STAFF REPORT

APPLICANT: Earl Baeten, et. al.  
DEVELOPMENT: body shop  
LOCATION: north side of Weaver Road  
ZONE: Industrial Two (I-2)  
DATE: May 9, 1990  
REMARKS:

The applicant is requesting a Conditional Use Permit to allow the construction of an automobile body shop. The 4.5 acre site, located on the north side of Weaver Road between Dixie Highway and I-75, is zoned Industrial Two (I-2) and is owned by Earl Baeten, et. al.

BOONE COUNTY BOARD OF ADJUSTMENT  
BUSINESS MEETING

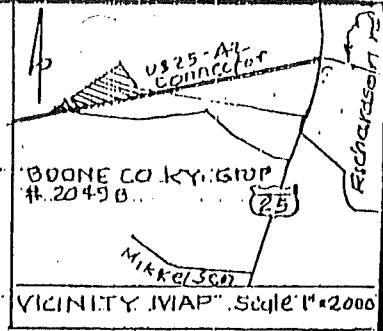
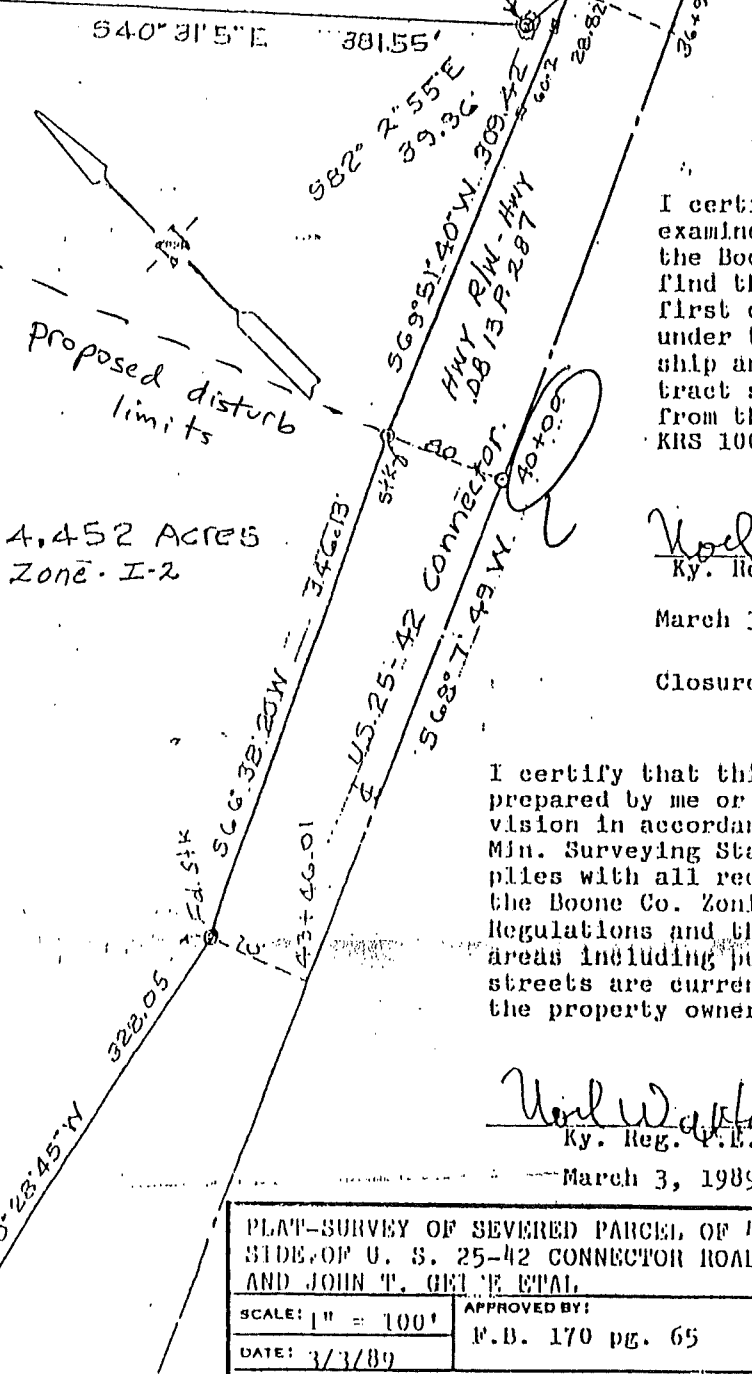
1. Staff is concerned with the potential loss of trees from this site. Therefore, staff would recommend as a condition, should this application be approved, that the applicant be required to maintain as many as the trees as possible. This condition could be met by requiring that the site not be disturbed west of the 40+00 station marker on Weaver Road and that at least 50 feet of the required front yard setback be maintained in its natural condition as a buffer from Weaver Road.
2. Staff would suggest as a condition of approval that the project be limited to a sign of no more than fifty (50) square feet in area and no more than ten (10) feet in height. This "monument" type sign will allow the body shop to remain in character with the purpose of the I-2 district and keep the body shop from detracting from the permitted uses in the district.

3. The applicant has proposed, on his concept plan, to position the body shop in a way which would screen the garage doors and outside storage areas from Weaver Road. Staff would recommend as a condition that this arrangement be made a condition should the permit be approved. In addition, staff would recommend that the storage area itself be screened. An adequate and appropriate means of accomplishing this buffer is to require that ivy be planted and maintained along the fence so that, once mature, there will be three "walls of green."

Mr. Ken Overhelm, an adjoining property owner, stated that the driveway is within 30 feet of his property line. He reviewed the drawing shown by Mr. Duncan and questioned their intention in regard to the driveway.

Proposed undisturbed area

Proposed undisturbed limits

Mr. Duncan advised that there will be some grading in the area of the driveway, but the trees and the hump between the properties will be left intact. It will be 80 feet to the building. They believe the existing natural buffer to be adequate.

Mr. Houston moved that the Conditional Use Permit be approved as it meets the criteria for a Conditional Use Permit as identified in the Staff Report, but subject to the conditions that the sign be no more than 50 square feet and ten feet high, that there be privacy slats in the chainlink fence, that the first 50 feet be left undisturbed, and that all possible trees be left in order to buffer adjacent property. Mr. Ryan seconded the motion and it carried unanimously.
